SEQUOYAH NUCLEAR PLANT
FINAL SAFETY
ANALYSIS REPORT
FIGURE 7.2.1-1 SHEET 19
FUNCTIONAL DIAGRAMS ENVIRONMENT
ALLOWANCE MOD & TRIP TIME
DELAY LOGIC
(REVISED BY AMENDMENT 13)

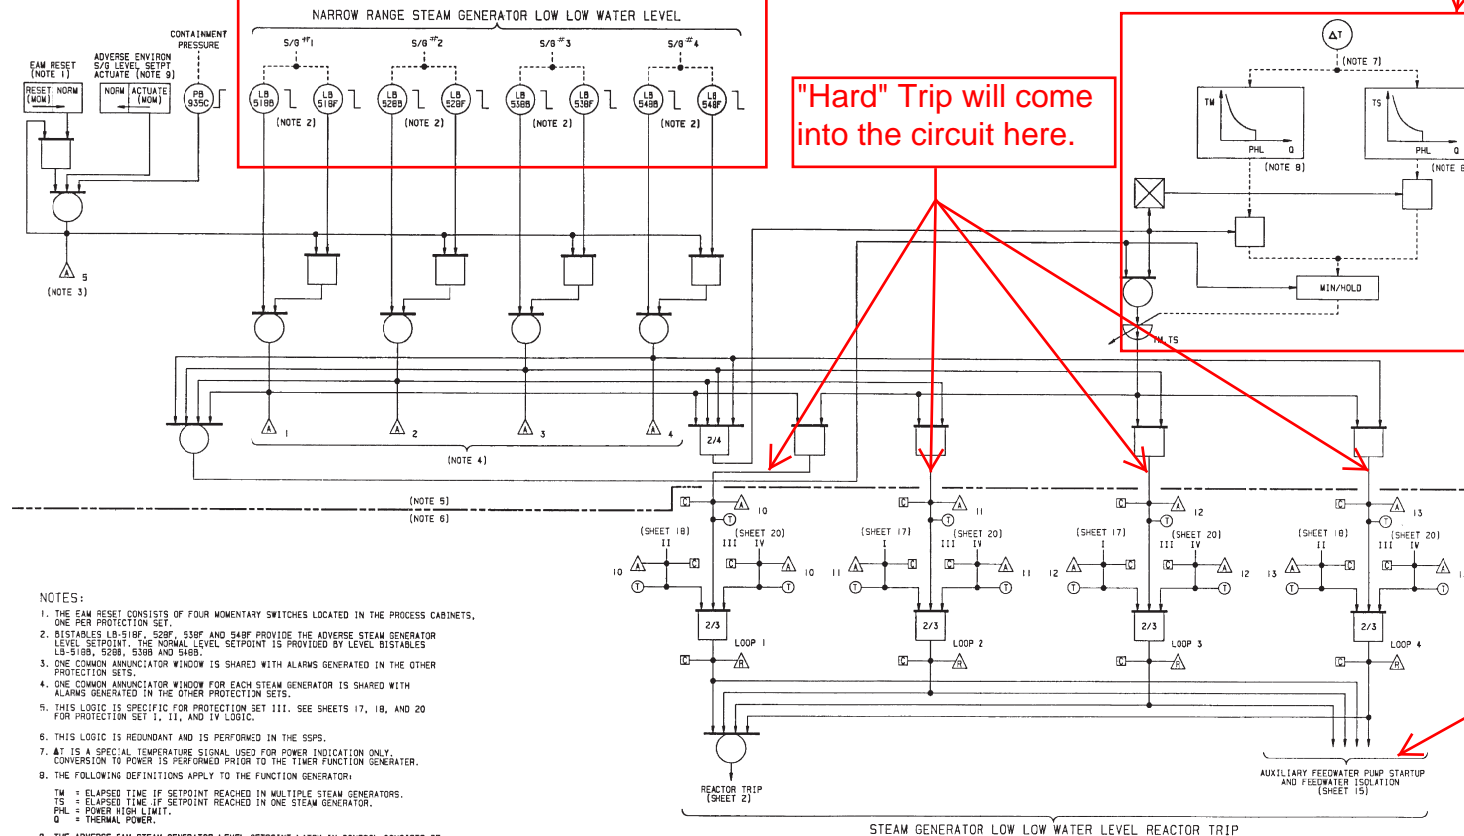
Only these S/G Level Trips are impacted

Different S/G Level Bistables from sheet 19

SEQUOYAH NUCLEAR PLANT
 FINAL SAFETY
 ANALYSIS REPORT
 FIGURE 7.2.1-1 SHEET 20
 FUNCTIONAL DIAGRAMS ENVIRONMENT
 ALLOWANCE MOD & TRIP TIME
 DELAY LOGIC
 (REVISED BY AMENDMENT 13)

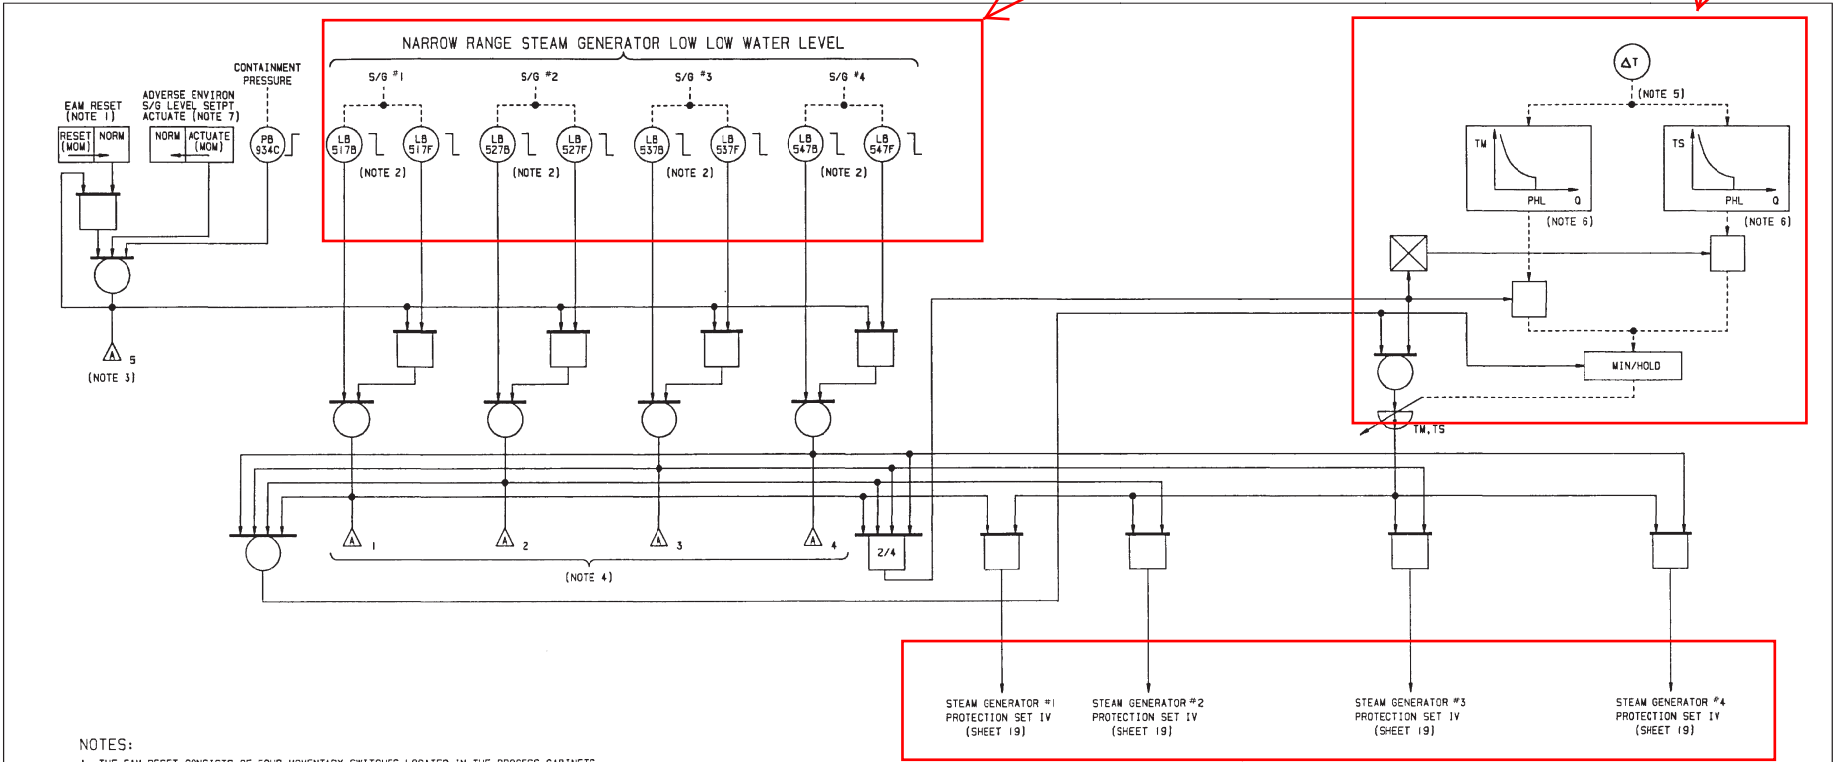
Different Delta T channel from sheet 19

Goes back to Sheet 19 for the Actuation Logic

SEQUOYAH NUCLEAR PLANT
 FINAL SAFETY
 ANALYSIS REPORT
 FIGURE 7.2.1-1 SHEET 19
 FUNCTIONAL DIAGRAMS ENVIRONMENT
 ALLOWANCE MOD & TRIP TIME
 DELAY LOGIC
 (REVISED BY AMENDMENT 13)

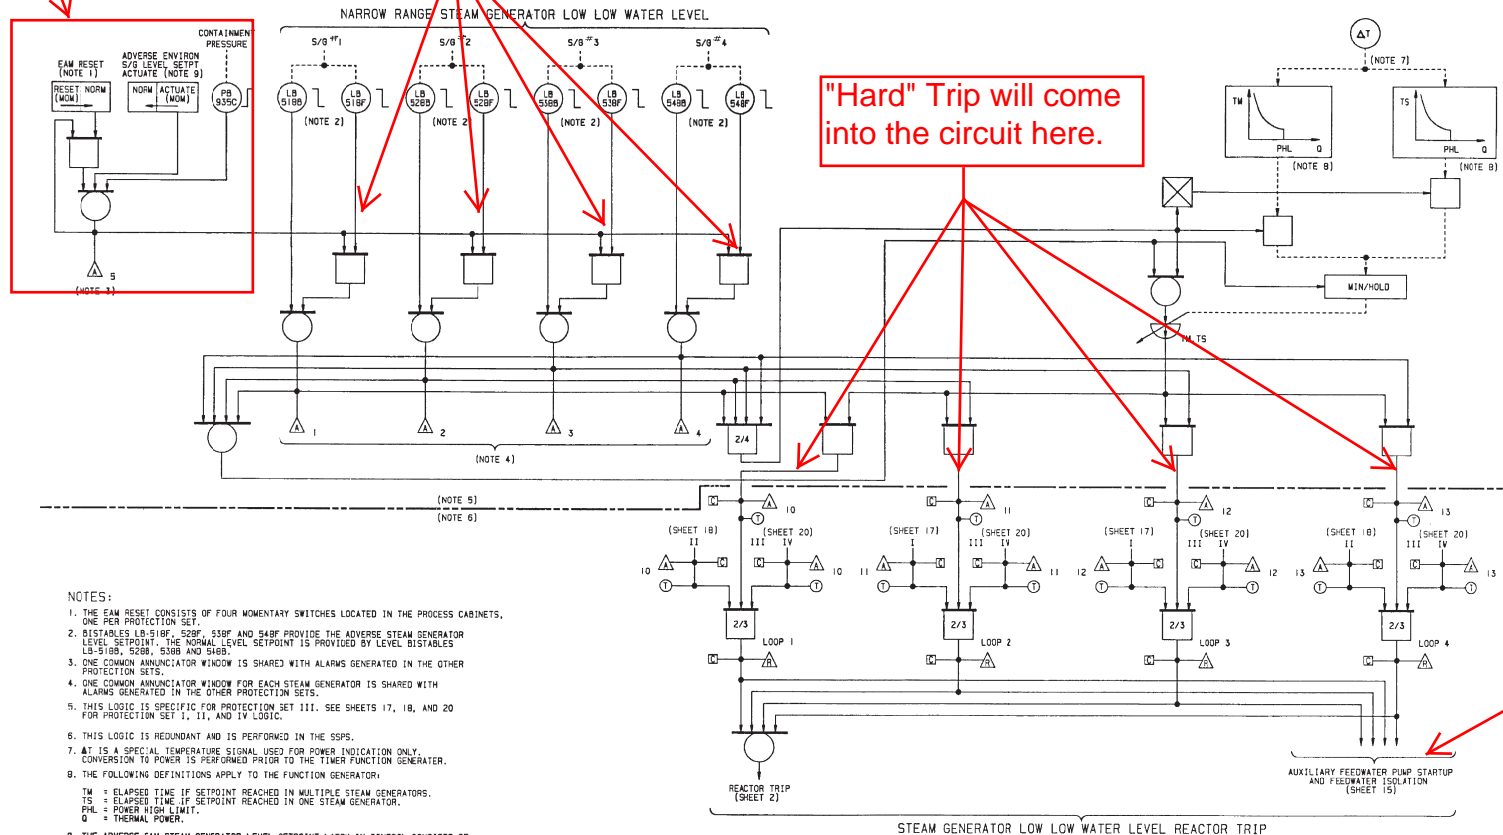
EAM Failure would impact this part of the circuit

EAM Failure would only impact these S/G Level Trips

"Hard" Trip will come into the circuit here.

SEQUOYAH NUCLEAR PLANT
FINAL SAFETY
ANALYSIS REPORT
FIGURE 7.2.1-1 SHEET 20
FUNCTIONAL DIAGRAMS ENVIRONMENT
ALLOWANCE MOD & TRIP TIME
DELAY LOGIC
(REVISED BY AMENDMENT 13)

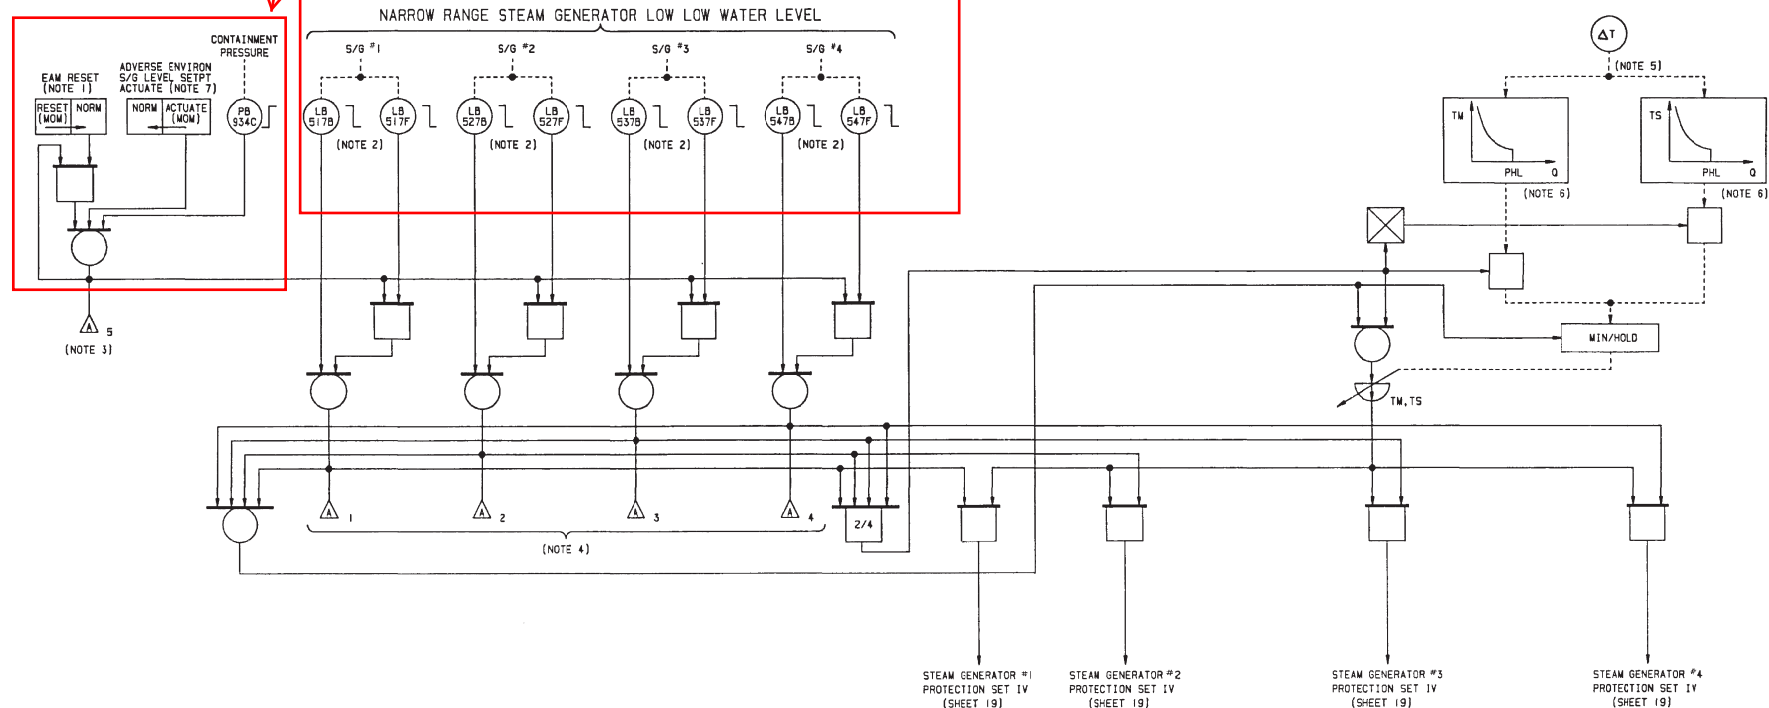
Separate Containment
pressure bistable from
sheet 19

Different S/G Level
Bistables from
sheet 19
